**CEQA Addendum
Zone 7 Water Agency
Altamont Water Treatment Plant Project**

State Clearinghouse No. 2000032009

July 2006

Figure 2-1
Project Feature Revisions

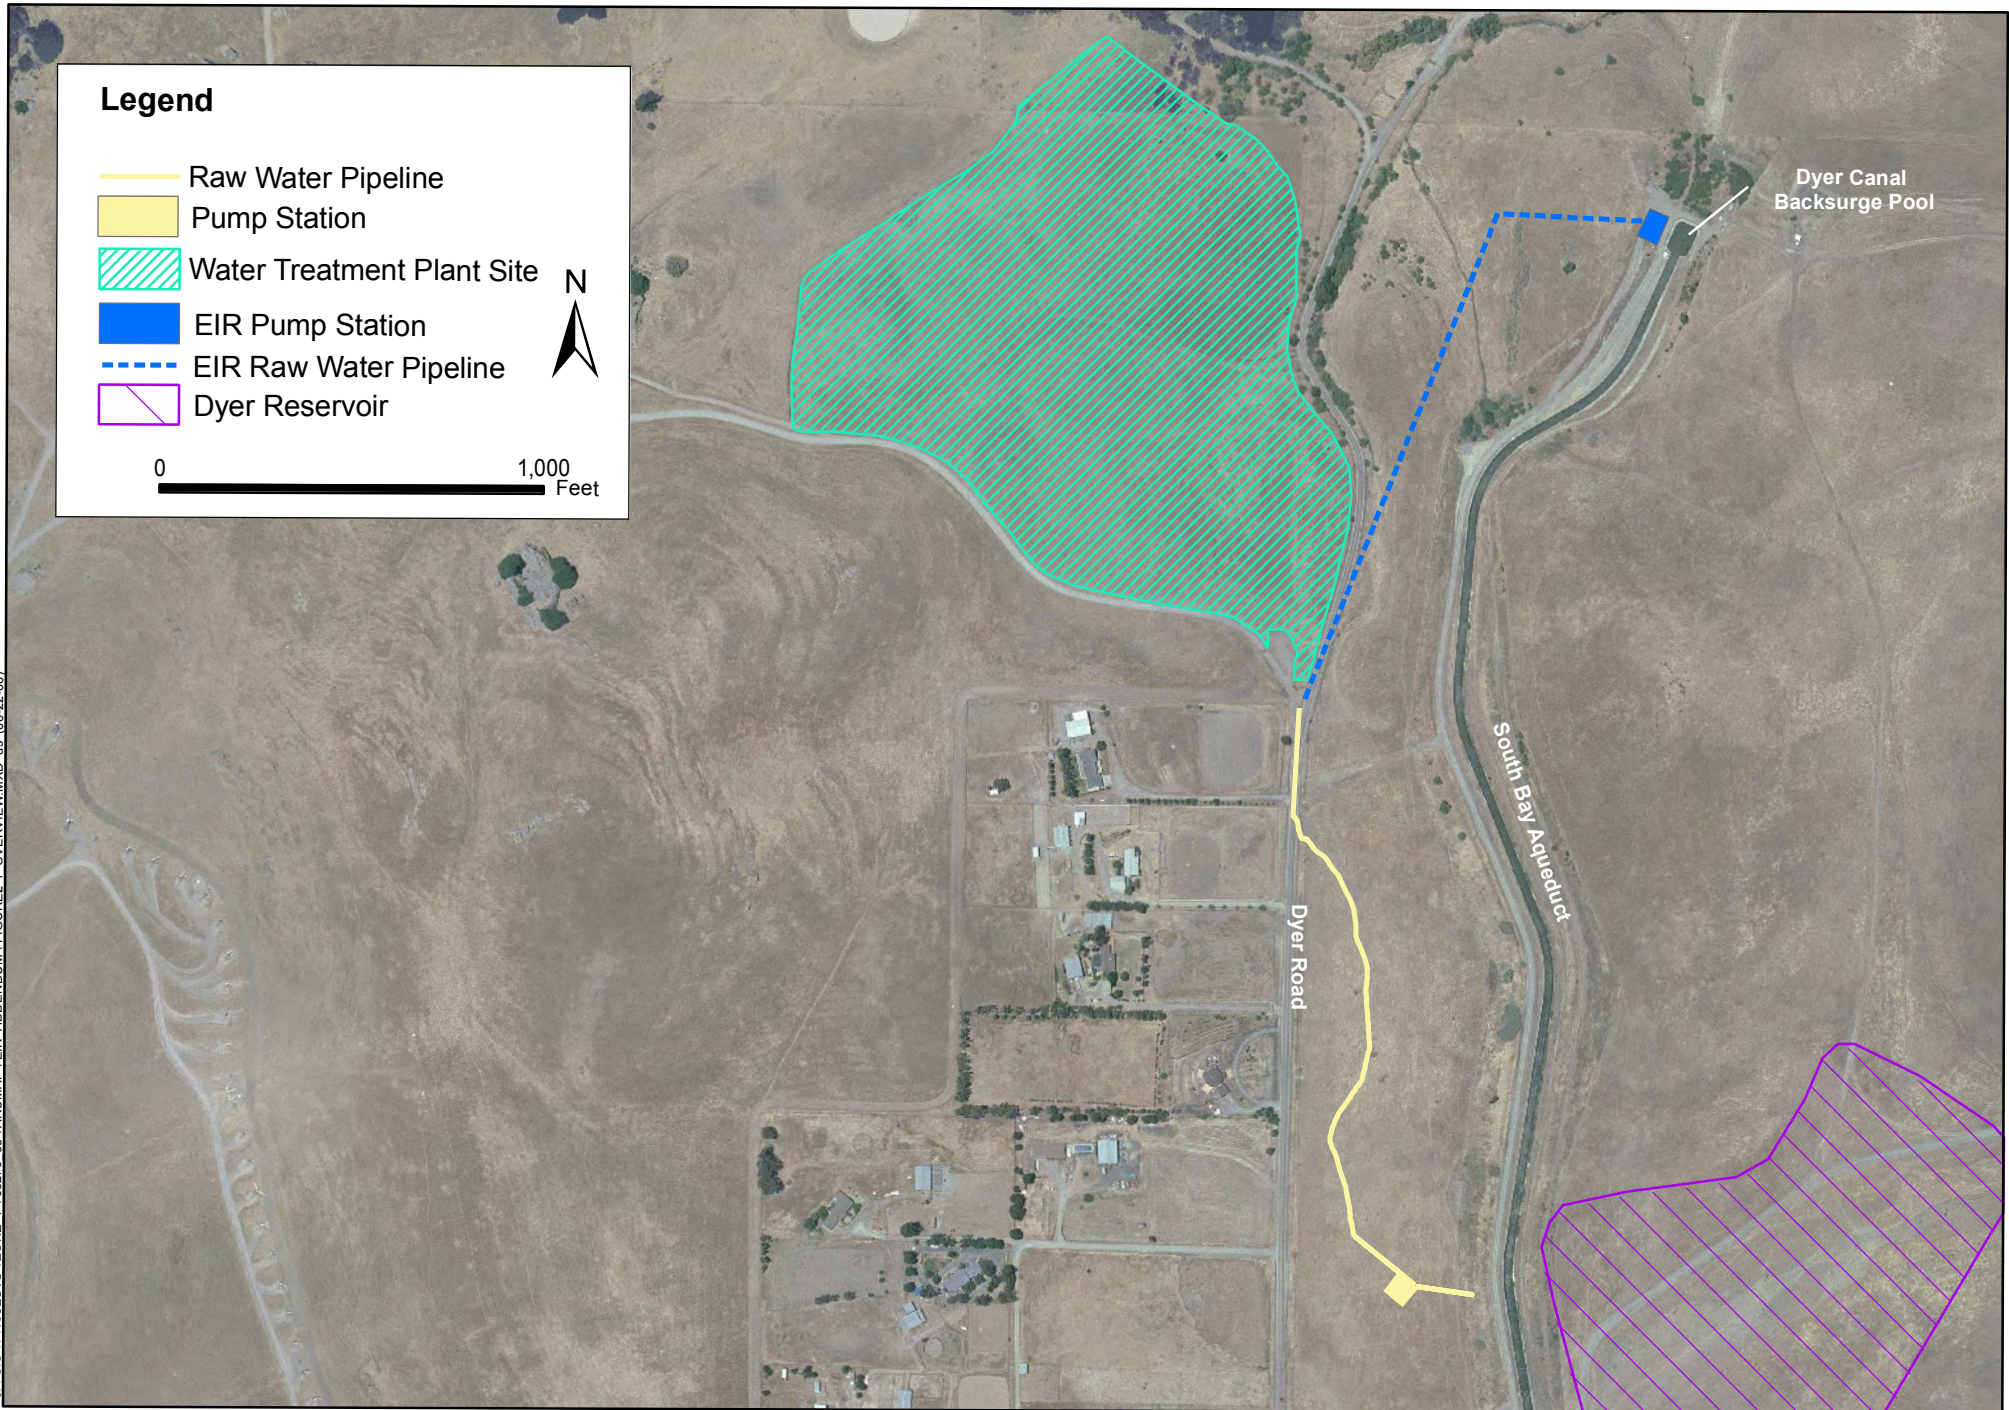
The EIR previously identified the location of the pump station at the Dyer Canal Backsurge Pool with a raw water pipeline routed from the pump station to the AWTP. The revised design for the raw water pump station and raw water pipeline would transfer water from the South Bay Aqueduct (SBA) at Dyer Reservoir¹ to the AWTP (See Figure 2-1). Accordingly, the raw water pipeline and the raw water pump station are now proposed to be located adjacent to Dyer Reservoir along Dyer Road.

05275.05 Raw Water Pumping Station Site Plan

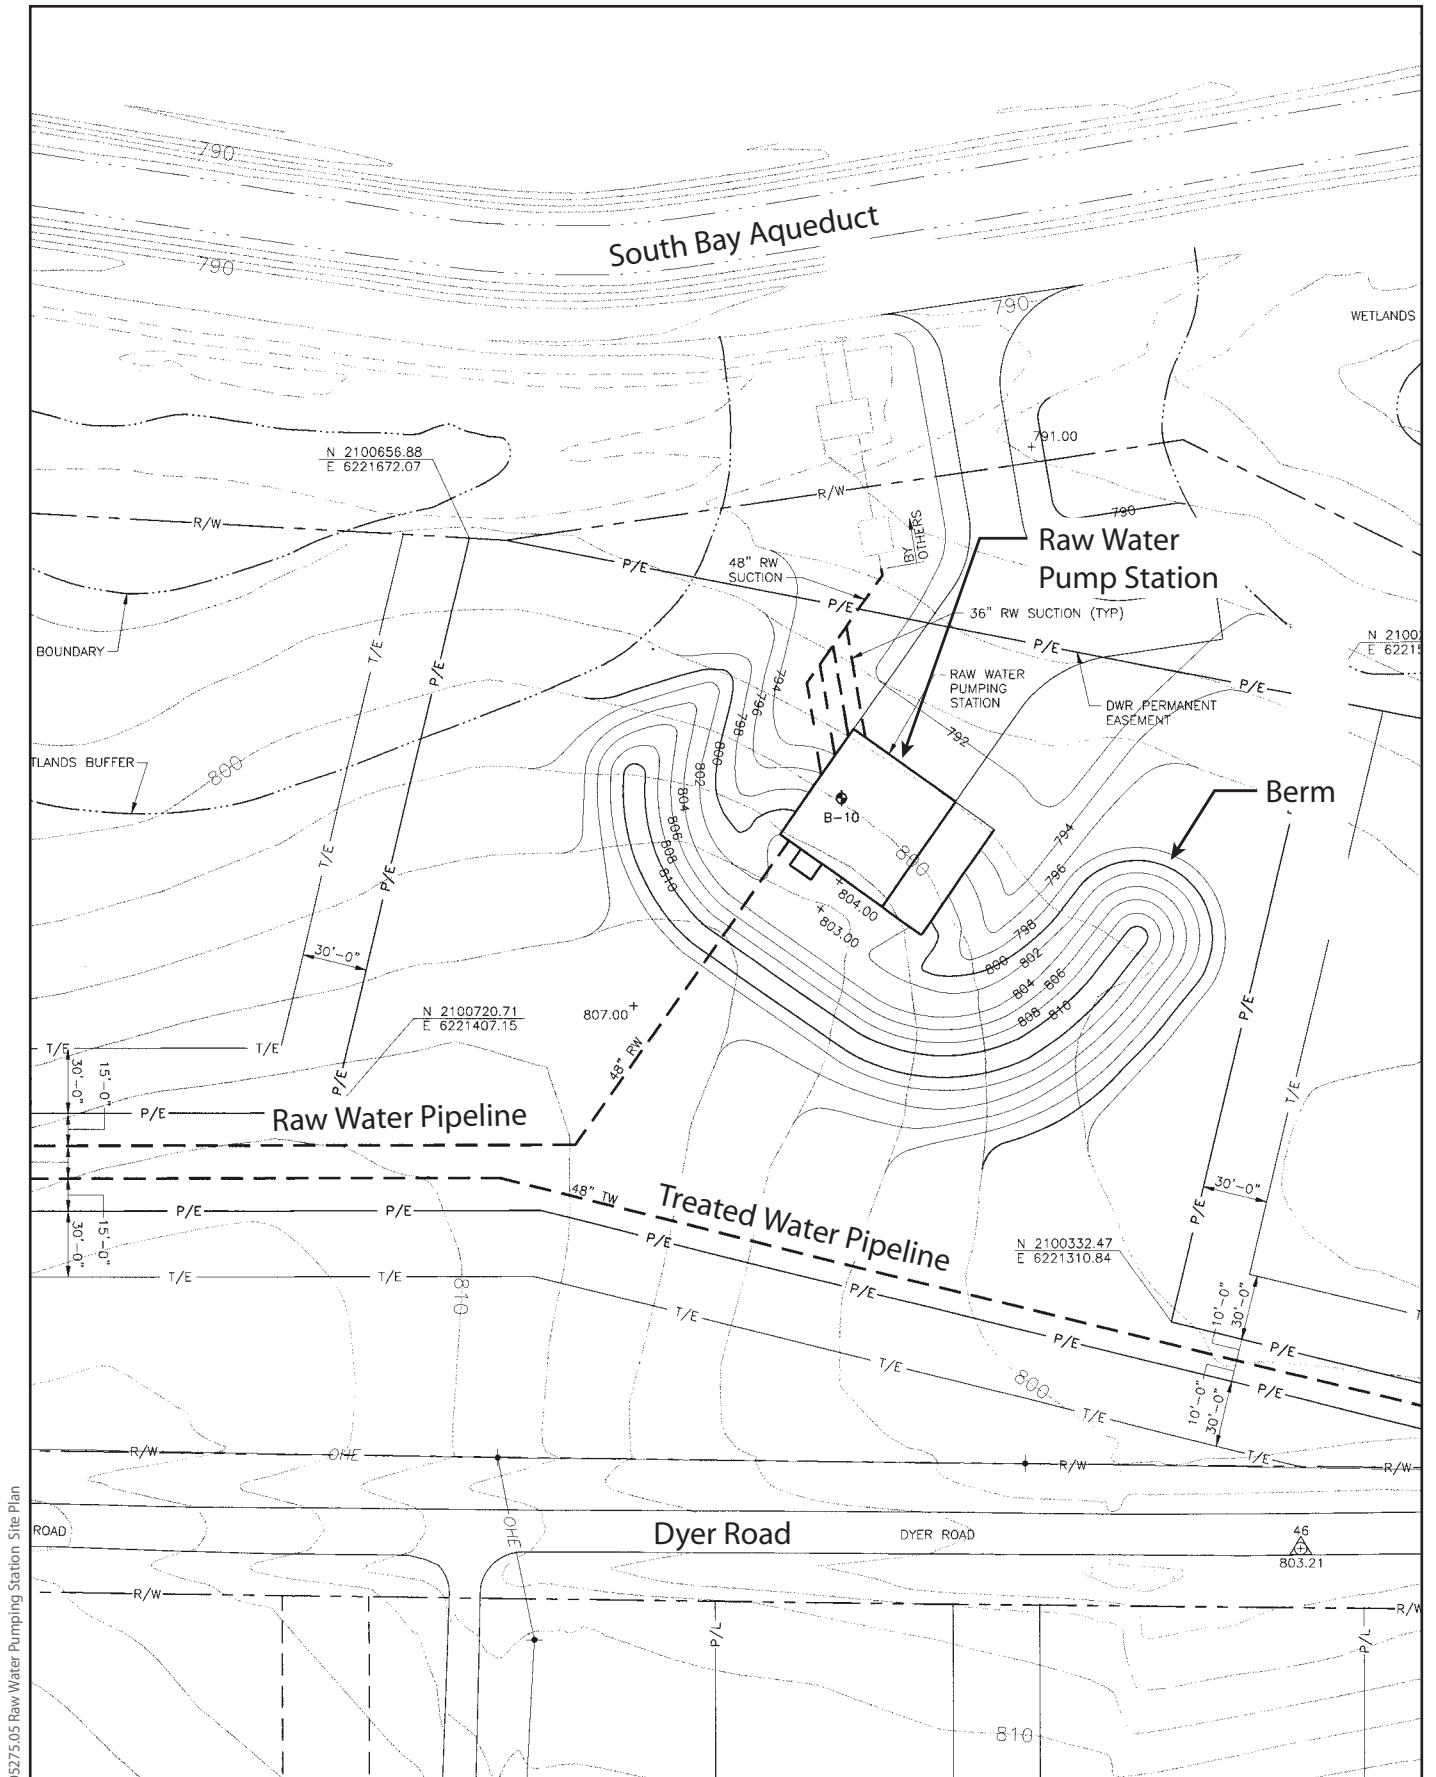
The pump station would be a concrete structure at grade with superstructure covering the facility (See Figure 2-2). The building would be approximately 57 feet by 57 feet, and approximately 17 feet tall (placed partially below grade). The structure would include an additional 21-foot length of walled, unroofed area to house a transformer and other facilities. The footprint of the facility, including adjacent cleared areas, would be approximately 80 feet by 80 feet. The superstructure would be concrete with a concrete roof. The size of the pump

station would accommodate the current demand of 24 mgd with provisions for future demands up to 42 mgd. Three vertical electric turbine can-type pumps would be installed to provide a firm capacity (i.e., with one pump out of service available as a back-up) of 30 mgd. Space for a future electric pump would be provided for a future firm capacity of 45 mgd. The pumps would be equipped with variable frequency drives to accommodate a full range of flows to the AWTP. Back-up electrical power will be supplied from the AWTP. The pump station would be sized to accommodate future addition of potassium permanganate, a pre-oxidant chemical.

Figure 2-3
Visual Simulation of the Raw Water Pump Station as Viewed From Dyer Road

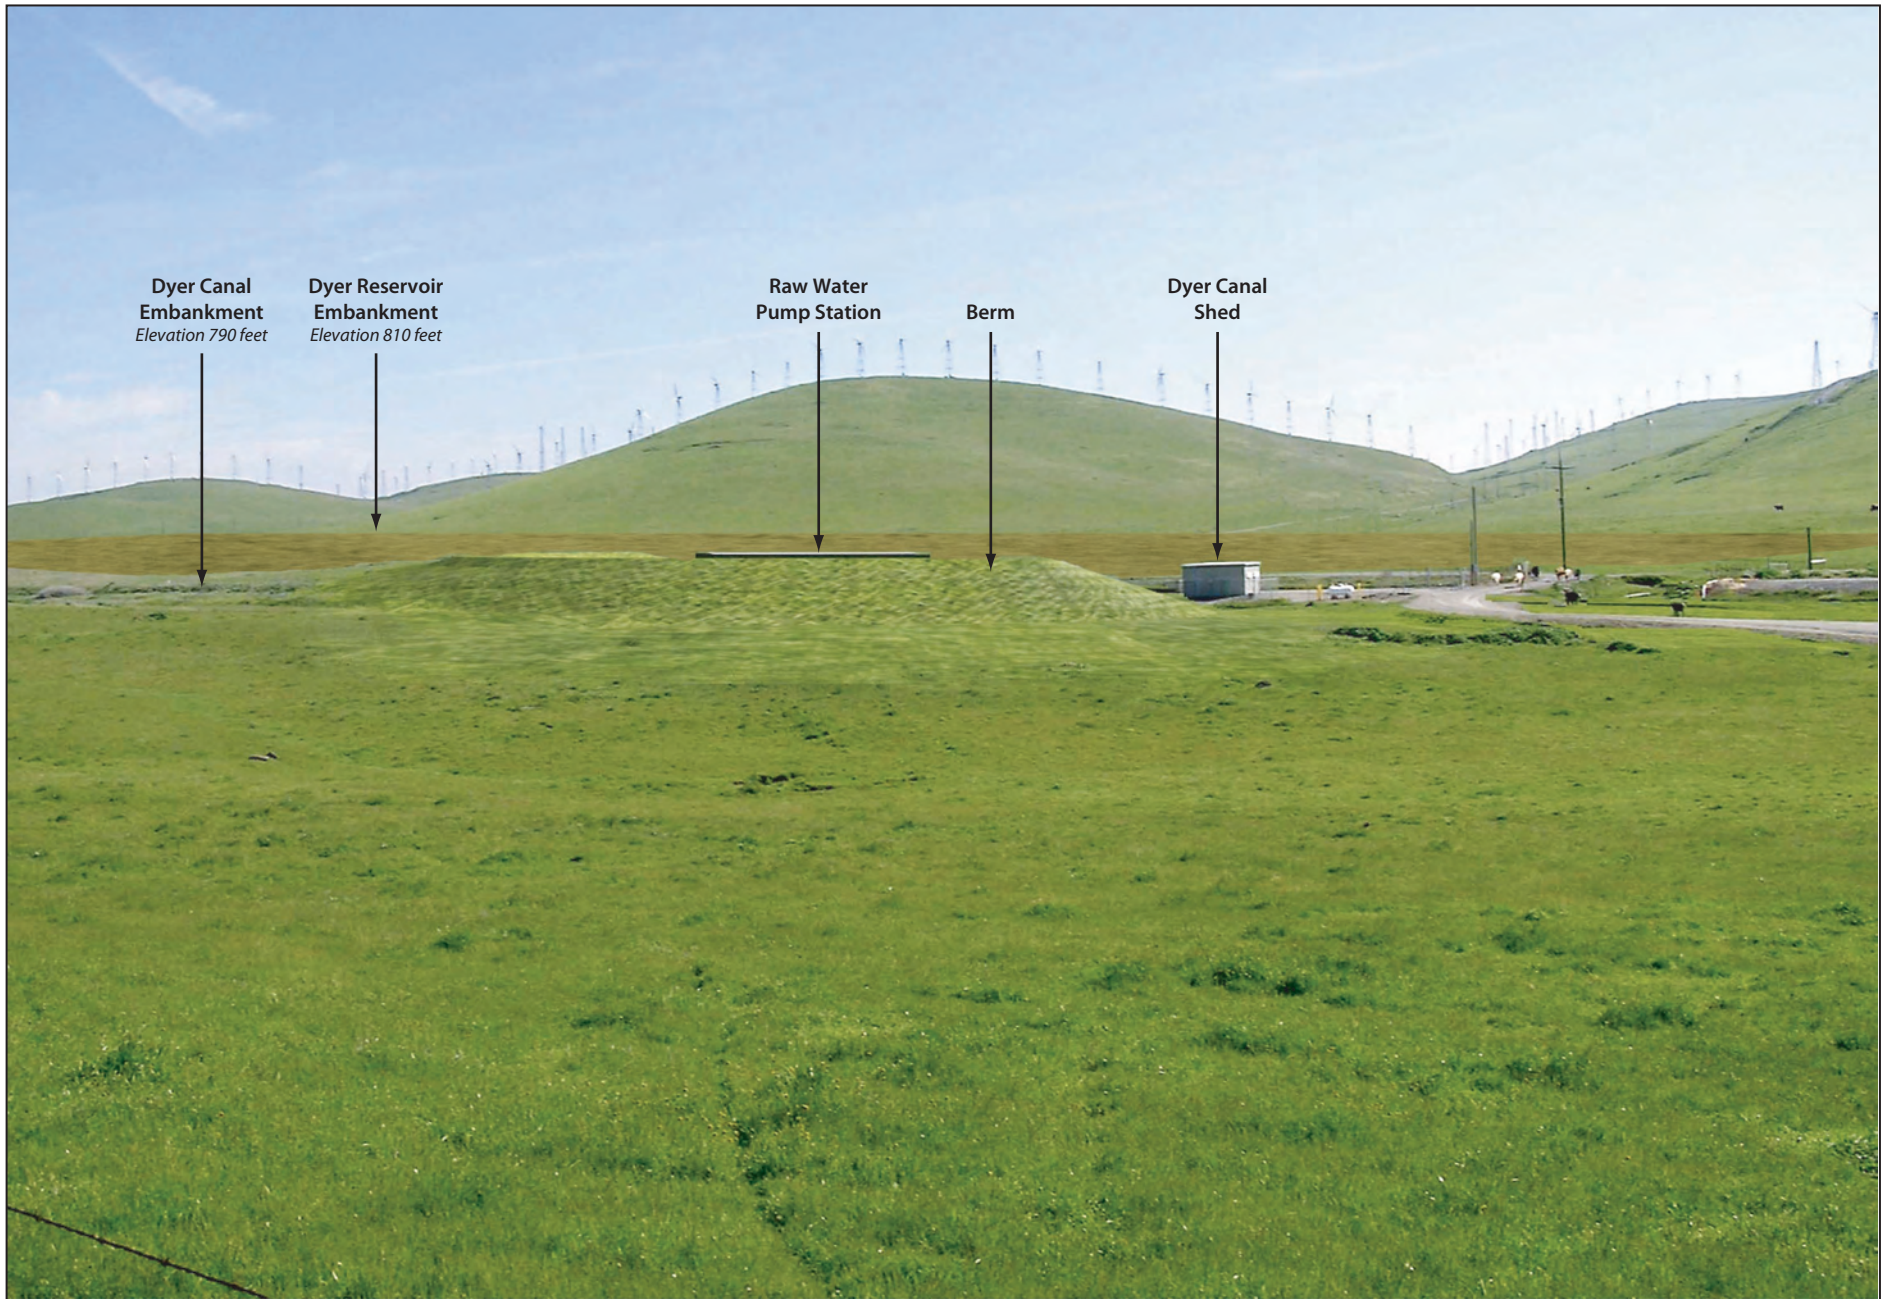
A 10-foot-wide permeable all-weather access road (e.g., gravel, recycled concrete) would extend approximately 250 feet from the existing SBA access road to the pump station. Parking at the pump station also would consist of a permeable all-weather surface to accommodate a boom truck and a regular maintenance pick-up truck. A 10-foot high earthen berm would be placed on the north, west, and south sides of the pump station to screen it from the Dyer Road vicinity. The berm would be landscaped with annual grassland species comparable to the surrounding grassland (See Figure 2-3).
